Product Change Notification

1. ECN #: 240176

- MPSS - 5mm (.197") Mini-Power Discrete Wire Cable Assembly

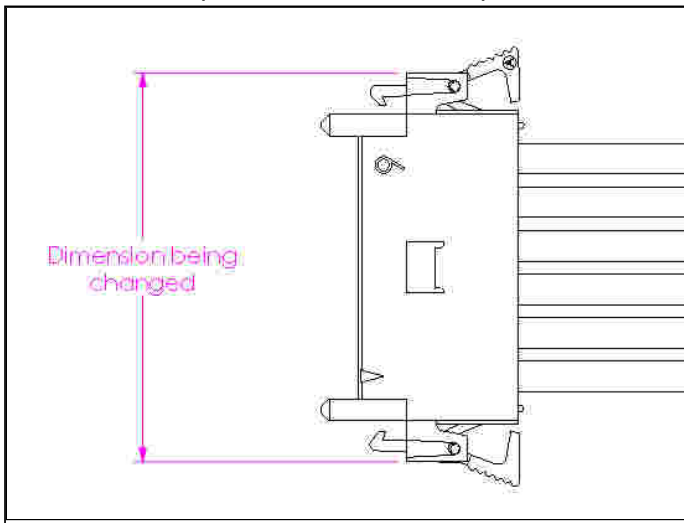
The ears that hold the latches are increasing in size by 0.5mm. The latch positions will not move. This will be a rolling change.

Measure across the longest part of the body (see picture). Old product should be 5mm x positions + 14.66, and new product will be 5mm x positions + 15.66

The corners on those latch ears were breaking during shipment of the bodies. The latch function was not altered, but there was a visible break and added debris on the cable. This change should reduce that condition.

- Fit - Increased length of the cable end
